**GENERAL
CORRESPONDENCE**

CERTIFIED MAIL
RETURN RECEIPT REQUESTEDMr. Kenneth E. Beasley III
Compliance Engineer
El Paso Natural Gas Company
P. O. Box 4990
Farmington, New MexicoRE: Discharge Plan (GW-33) Modification
El Paso Natural Gas Company
San Juan River Plant

Subject: Discharge Plan for El Paso Natural Gas Company -
San Juan River Plant, GW-33

CEDERGREN'S METHOD FOR SEEPAGE CALCULATION

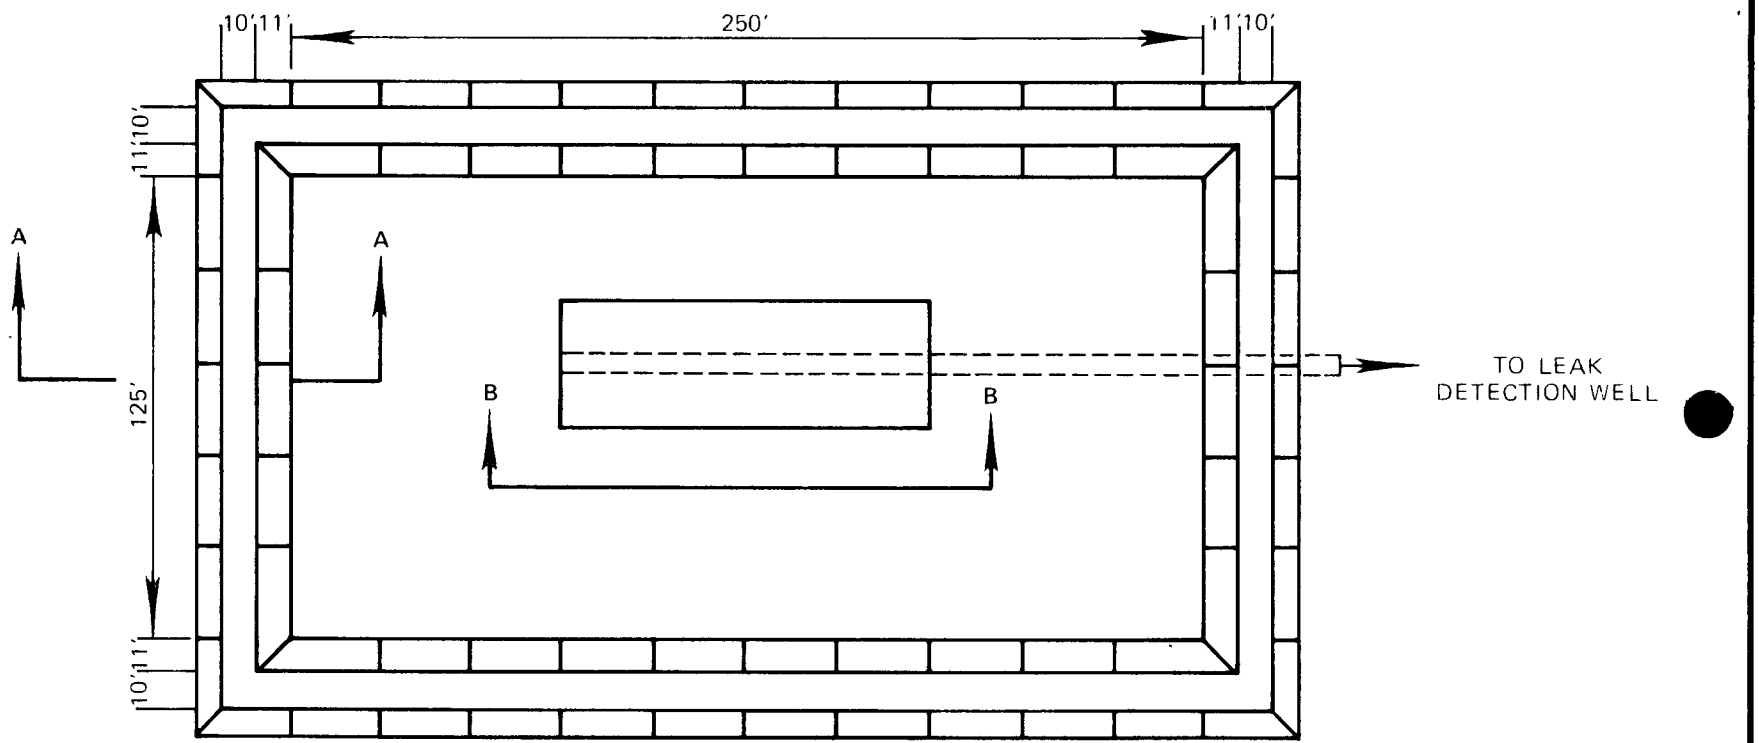
1. Provide the appropriate section for the Cedergren reference. What were the reference points for the head differential determination?

Response: Enclosed is the appropriate section from the Cedergren reference for the determination of seepage from the unlined evaporation ponds. The points of reference for the head differential determination were the elevation of the pond given on plate 7 and the potentiometric surface determined by our consultants.

CONCEPTUAL DESIGN OF MODIFICATION
TO WASTEWATER MANAGEMENT SYSTEM—
SAN JUAN RIVER PLANT

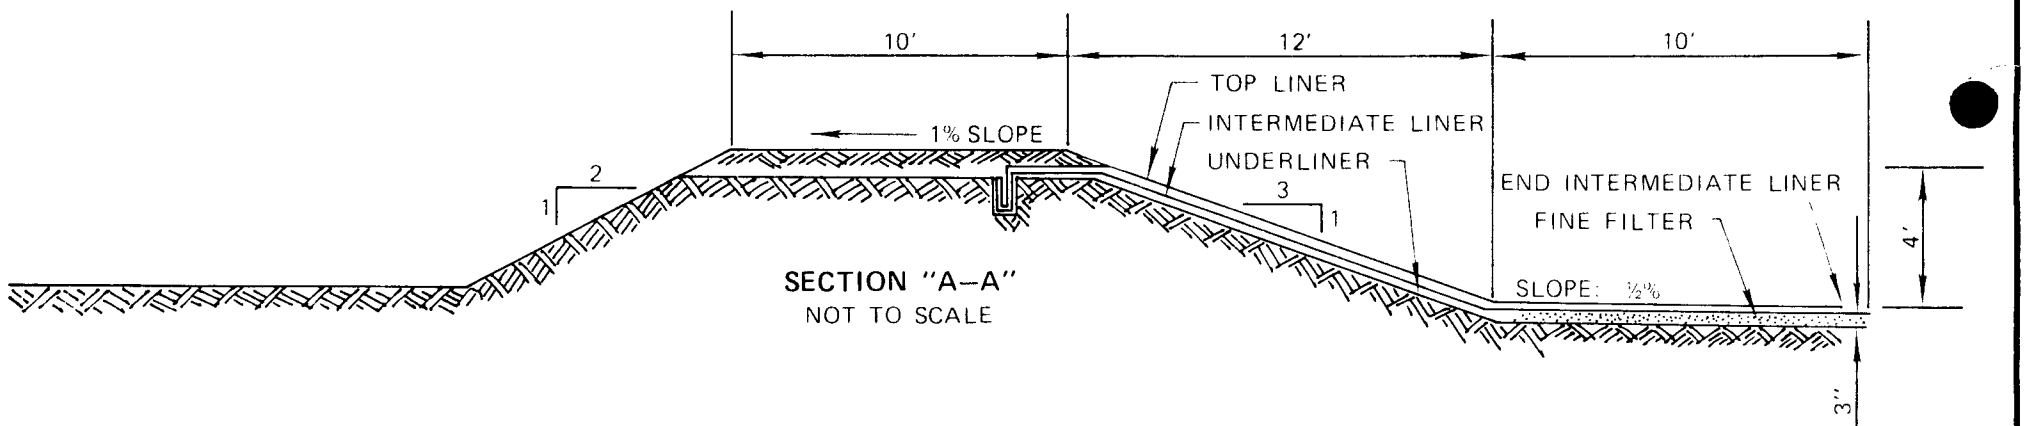
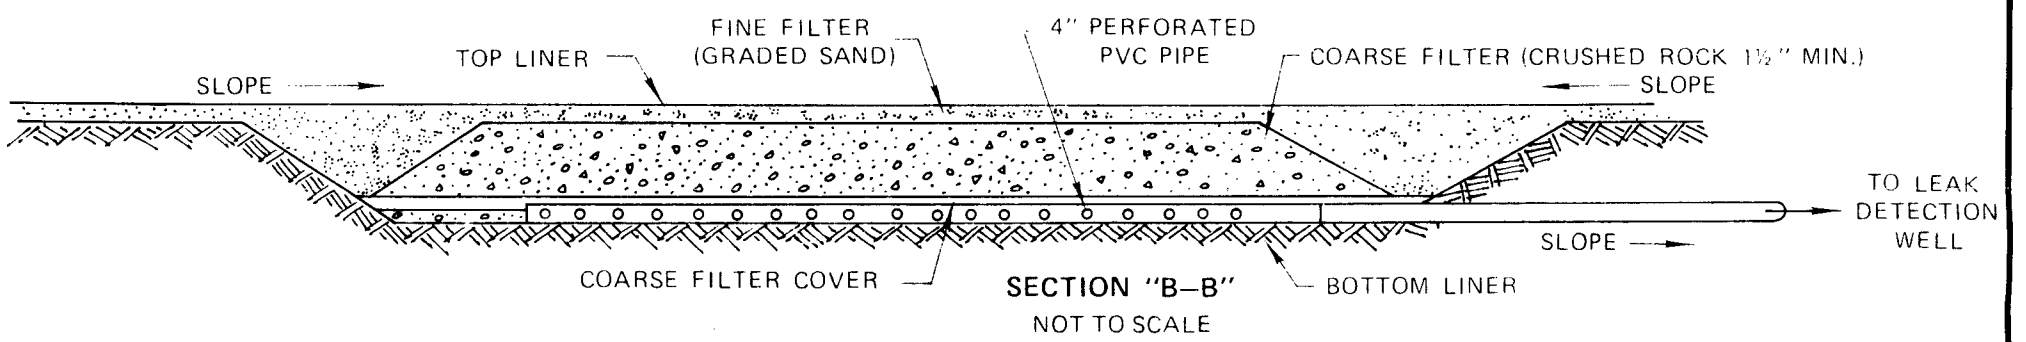
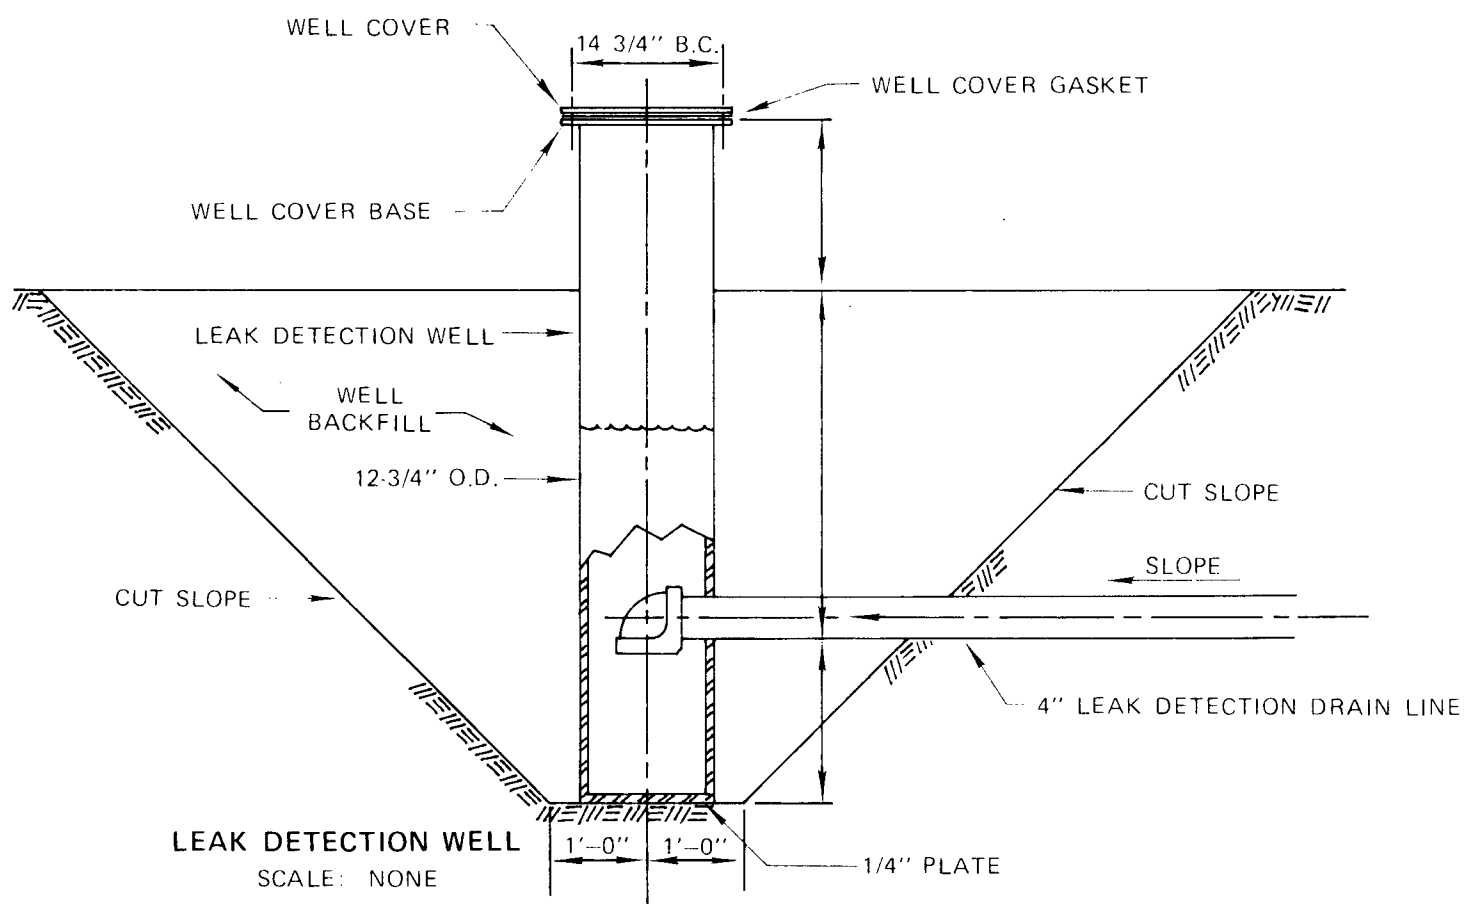
Questions 1 through 4 relate to inconsistencies or missing information in the conceptual design for the contact wastewater system. Since some minor modifications have been made in the conceptual design, the following narrative and enclosed drawing will serve to address those questions relating to materials and construction for the pond system.

A drawing showing the typical conceptual design details for one cell of the dual-celled contact wastewater lagoon is enclosed. The design is based on available data, is conservative in terms of capacity and structural strength, and one which El Paso has employed successfully in other locations. The design of the proposed contact wastewater lagoon is based on a normal contact wastewater flow of about 4000 gpd. It is also necessary to ensure that adequate capacity exists for any period of excessive flow or unusually wet weather. Total storage capacity of the lagoon system is approximately 4.6 acre feet, or 1,500,000 gallons. Average annual floating-pan evaporation is 4.17 feet per year, indicating that an evaporative capacity (surface area) of about 1 acre would be sufficient for total evaporation of contact wastewater. A surface area of 1.4 acres is proposed for contact wastewater to safely hold all of the plant's maximum expected contact wastewater discharge, plus a reserve capacity.

The cell bottom will be sloped at a rate of approximately 1/2% along the entire length of the pond toward the center where a perforated PVC pipe will be installed between the top and bottom layers for leachate collection. This pipe will be sloped at approximately the same rate to ensure the flow of leachate toward the leak detection well located outside of the pond berm. The layer between the liners, shown as fine filter material on the conceptual drawing, will consist of graded sand with round or subround particles not greater than 1/4 inch in size. The coarse filter material in the leak detection sump will be crushed rock with a size of 1 to 1 1/2 inches.
